Bulletin # BU-932

SERVICE BULLETIN

Ride Name: StarTrooper

Summary of Issue: Please review the attached drawing. If the spring break valve on your StarTrooper is plumbed like Exhibit B change the plumbing to match Exhibit A.

AIR BRAKE LINES

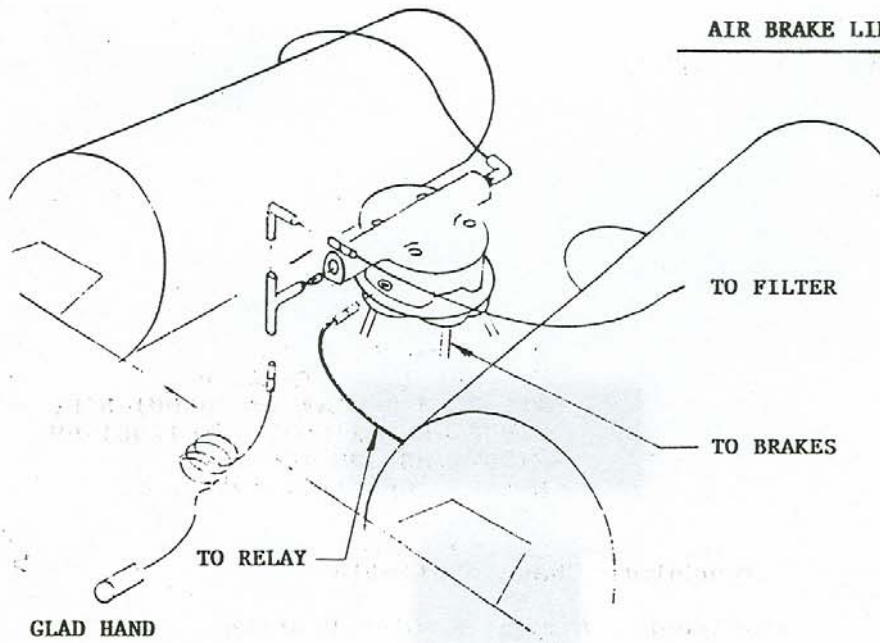
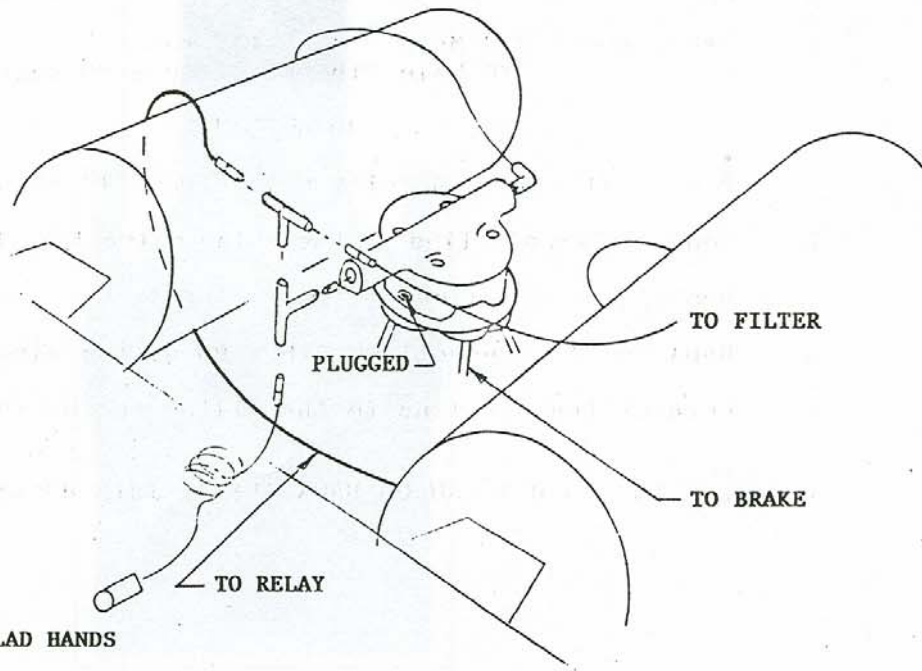
Reason for release: It is possible that the trailer brakes on some StarTrooper's were incorrectly plumbed. The incorrect plumbing does not effect the operation of the trailer brakes. However, when the StarTrooper is disconnected from the tractor air will not be trapped in the holding tank. Several minutes will be required to build up air in the tank before departing. Changing plumbing to the configuration of Exhibit A will correct this problem.

1. Remove airline to relay valve from "T" connection.
2. Connect the airline to relay valve into plugged port.
3. Remove the airline to the filter from "T" connection.
4. Replace "T" connection with a 90-degree elbow.
5. Connect the airline to the filter to the 90-degree elbow.
